Product Change Notification / SYST-24GQSM275

ERRATA - AVR64DB28/32/48/64 Silicon Errata and Data Sheet Clarifications Errata Document Revision

AVR64DB28/32/48/64

Silicon Errata and Data Sheet Clarifications

Figure 34-1. DAC Block Diagram

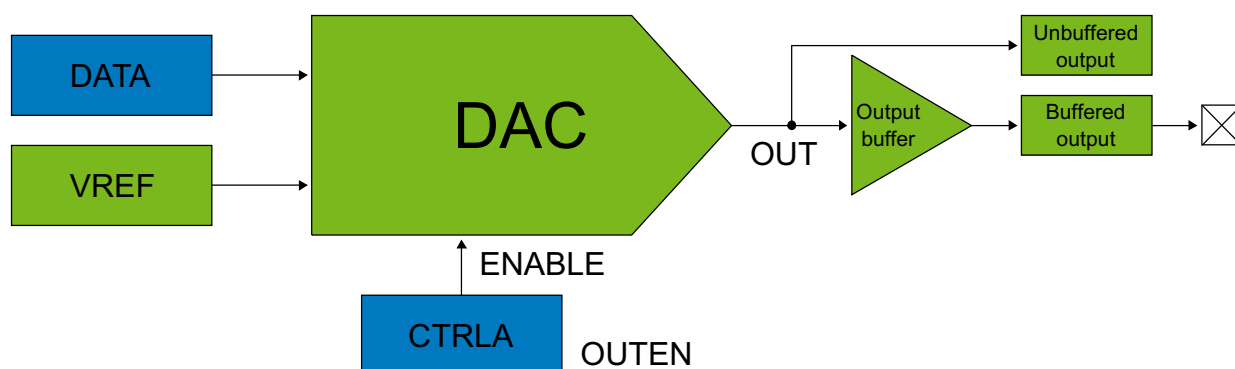
3.3.1 DAC Output

Clarifications of the block diagram and the DAC Output sub-section of the DAC peripheral has been made:

1. The block diagram is updated with clarifications to the output signal routing (buffered/unbuffered) and will replace the original block diagram.
2. Sections 34.3.2.3 (DAC as Source For Internal Peripherals) and 34.3.2.4 (DAC Output on Pin) are replaced by section 34.3.2.3 DAC Output.
